May 13, 2025

RE: Ted Franciscotti Pit #1, Permit No. M-2007-006, Technical Revision (TR2), Adequacy Review-1

Figure 1: (1) Depiction of the permit boundary over aerial imagery from the original permit. (2) The Division's estimation of the permit boundary. (3) The permit boundary depicted on the TR2 Reclamation Map.

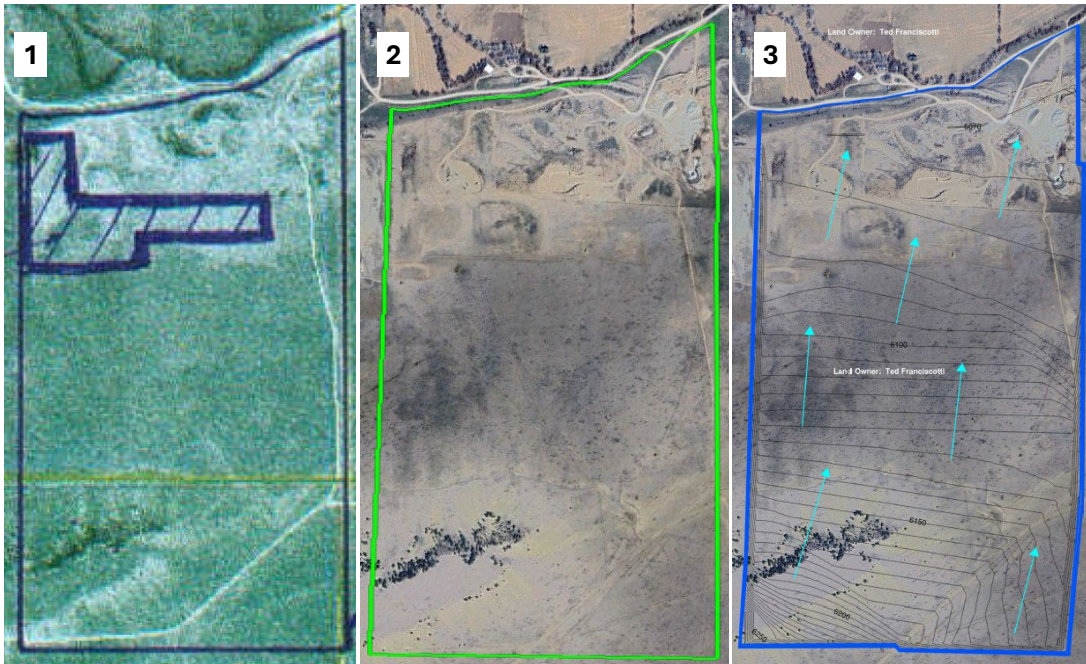
1. The permit boundary depicted on the Mining Map appears to have a different shape in comparison with the currently approved boundary (see Figures 1-2 below). Additionally, the Applicant's TR2 form states that the permit acreage is the same as what is currently approved (282 acres) but the TR2 Reclamation Map states that it is 277 acres.

- a. It appears that the boundary may have been shifted to more closely follow property fence lines than what was previously depicted. If that is the case, and if that is what's causing the 5-acre difference, the Applicant must first apply for an acreage reduction to request the removal of the excess acreage.
- b. The Applicant may instead reformat the maps to align with the original orientation – and include a separate affected area boundary that matches the 277 acres. Per Rule 3.1.12(2) the affected area boundary is what must be marked in the field.

Figure 2: The green polygon indicates the Division's approximation of the permit boundary. The blue polygon indicates the approximate location of the TR2 boundary. The TR2 boundary

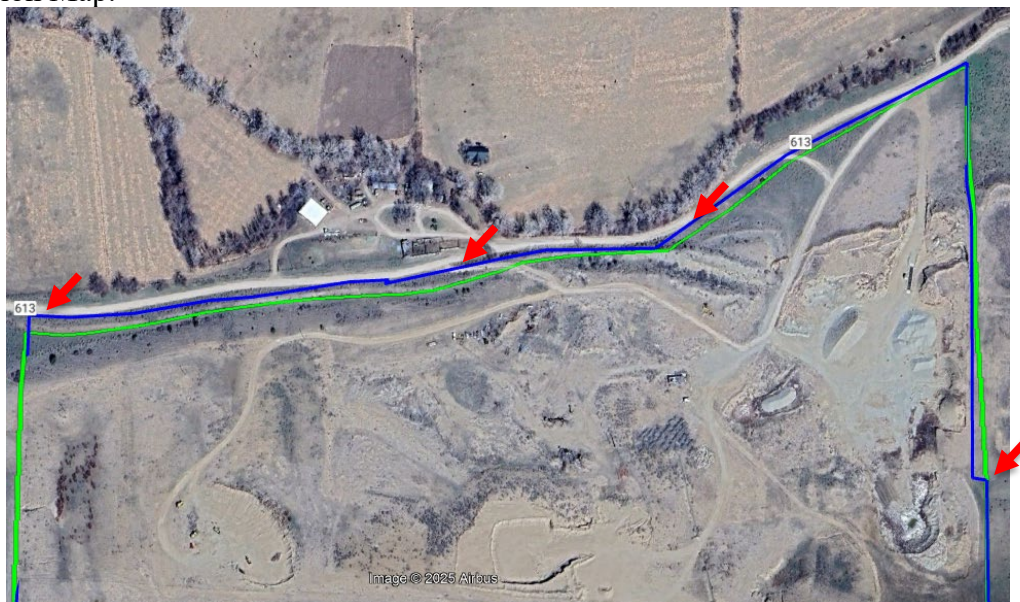
appears to follow the property fencing more closely. The red arrows highlight some of the differences. Also, see the southern boundary differences in the images in Figure 1.

Figure 3: Screenshot from the original/currently approved Mining Plan Map. The highlighted text indicates where a 30-foot buffer zone was planned around the boundaries.

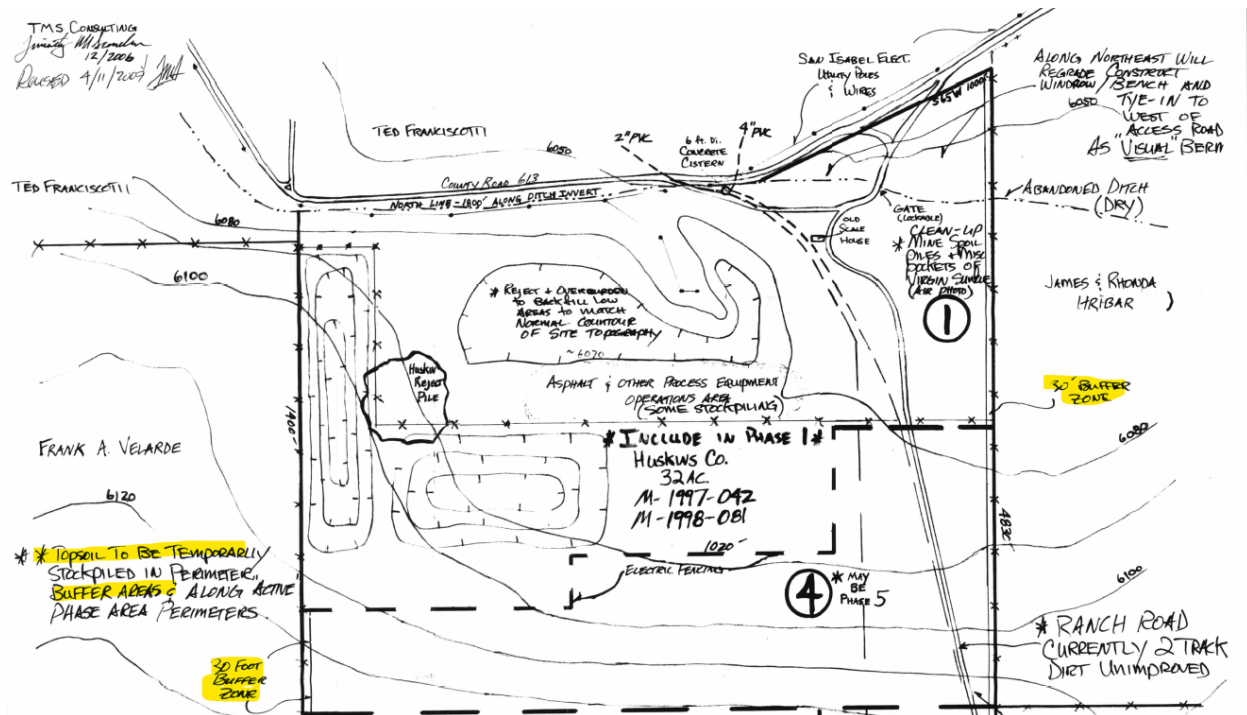
10. The current Mining Map indicates that there will be a 30-foot buffer area around the permit

area that will be used for topsoil stockpiling (see Figure 3 below). The Applicant's TR2 Mining Map appears to place the topsoil around this area in Phase I as well. Please clarify if the 30-foot buffer areas are to be maintained around where they are currently depicted – or if the Applicant instead intends to just ensure that topsoil is located outside of the ongoing mining activities in a perimeter configuration.
